**Contract Change Order # 1**

Project Name: Events Park Security Lighting Project Number: 176041  
 Project Location: Events Park Date of Application: Tuesday, January 9, 2018  
 Contractor: Third Generation Electric Submitted By: Daniel S.

## EVENTS PARK SECURITY LIGHTING

## ELECTRICAL PLAN

PROFILE SCALE:	DESIGN	DATE	DRAFTED	DATE
HORIZ.	CN	3-23-2017	CH	3-23-2017
VERT.	CN	3-23-2017	CH	3-23-2017
DRAWING NAME:	SHEET	E1	PROJECT NO.	
ELECTRICAL PLAN	OF	3	176041

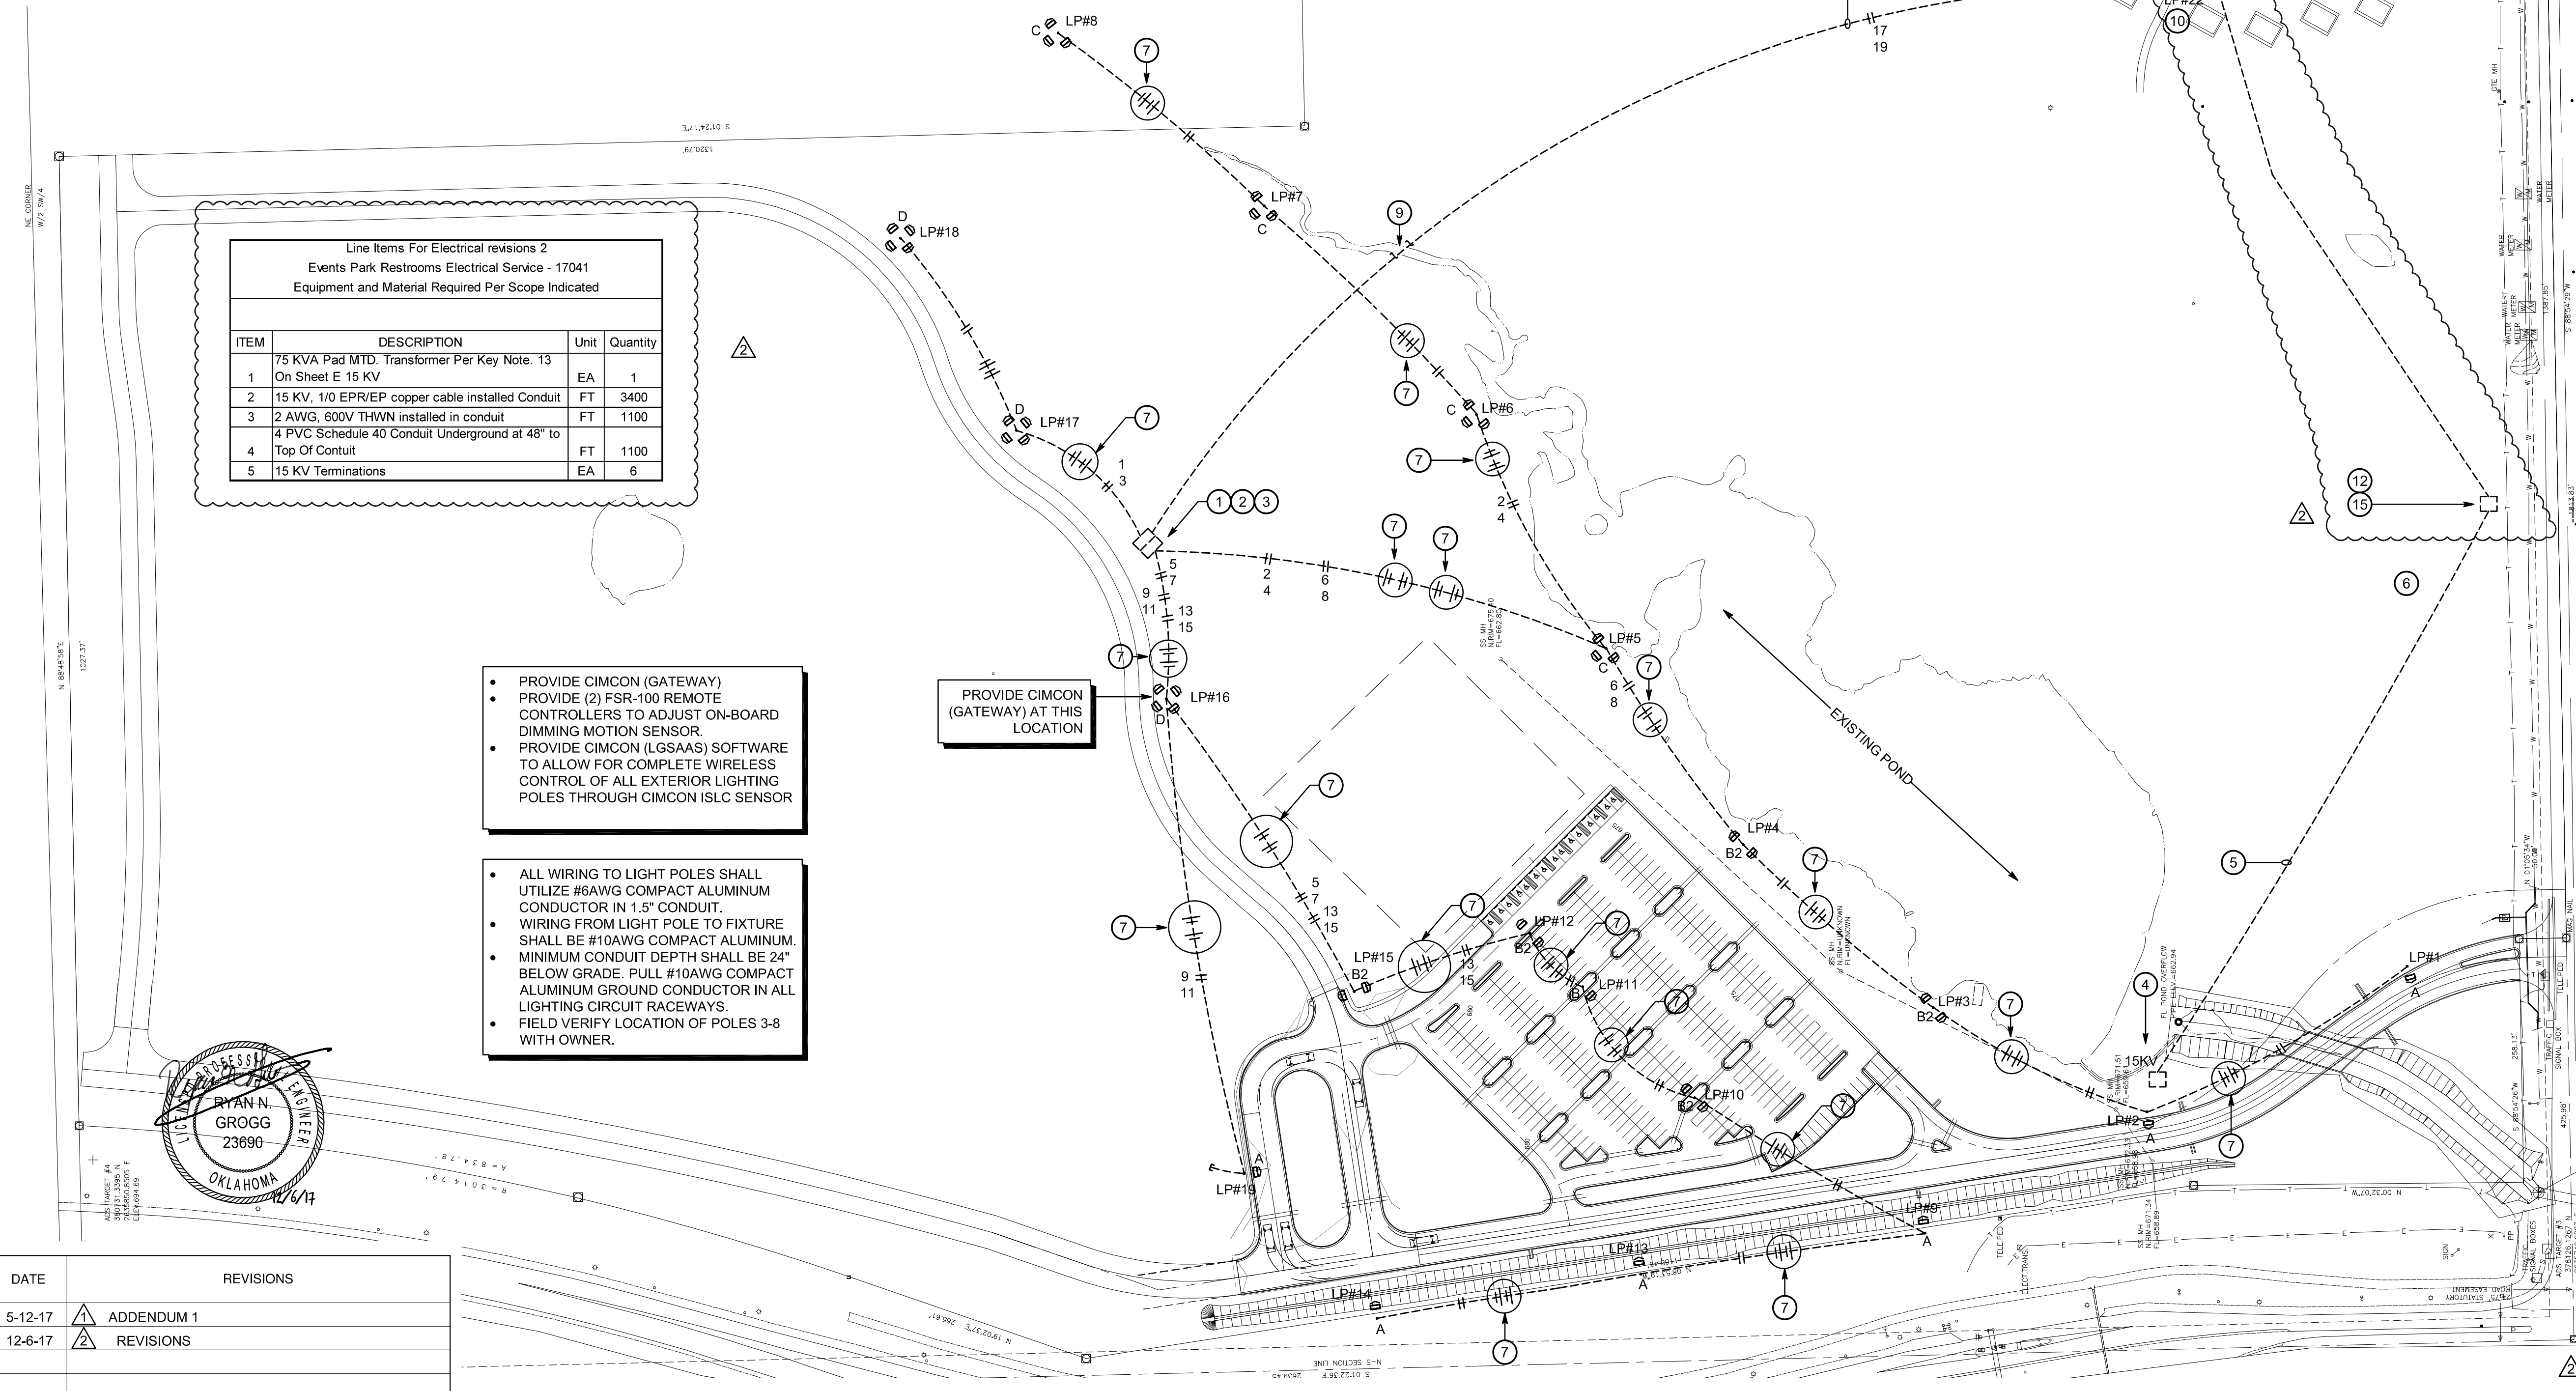
Due to revisions to the Events Park Restroom project, the 15Kv extension part of the additional alternate associated with this Security Lighting contract will be extended to service the restroom and playground complex. This extension is to include the line extension to the restroom building (1000 LF of service), installation of a 75Kva transformer, and all associated terminations and lines. The installation of  
 1) the 1000 LF of 4" conduit installed in place shall be extended through line item overruns in the base contract. The plans for installation are attached within and are to be incorporated into the contract documents. The costs summarized below are inclusive of all work described above and all applicable markups.

Electrical work per keynote 12,13,14, 15 Sheet E1 Events Park Lighting.

ITEM	DESCRIPTION	Unit	Quantity
1	75 KVA Pad MTD. Transformer Per Key Note. 13 On Sheet E 15 KV	EA	1
2	15 KV, 1/0 EPR/EP copper cable installed Conduit	FT	3400
3	2 AWG, 600V THWN installed in conduit	FT	1100
4	4 PVC Schedule 40 Conduit Underground at 48" to Top Of Conduit	FT	1100
5	15 KV Terminations	EA	6

- EXISTING 15KV TAP CABINET. EXTEND 15 KV FEEDER FROM TAP CABINET USING 3#1/0, SHIELDED, 'EPR' INSULATION, EP JACKET COPPER CONDUCTOR, #2AWG THWN GROUND IN 4" PVC CONDUIT & FEED NEW 75KVA PAD MOUNTED TRANSFORMER REF: KEYNOTE 15. MAINTAIN 15KV FEEDER MINIMUM 52" (TO TOP OF CONDUIT) BELOW GRADE. REFER TO INSTALLATION DETAIL.

- NEW PAD MOUNTED 13.2KV/208-120V, 3PH, 4W, DEAD FRONT, LOOP FEED WITH DRY CANISTERS & CURRENT LIMITING FUSES.  
TRANSFORMER WITH:  
a. COOLING PANELS

- ALL 15 KV TERMINATIONS MUST BE PERFORMED BY TRAINED & CERTIFIED TECH. USE 3M, COLD SHRINK QT-II, 15 KV 5633K OR EQUAL TERMINATION KIT.
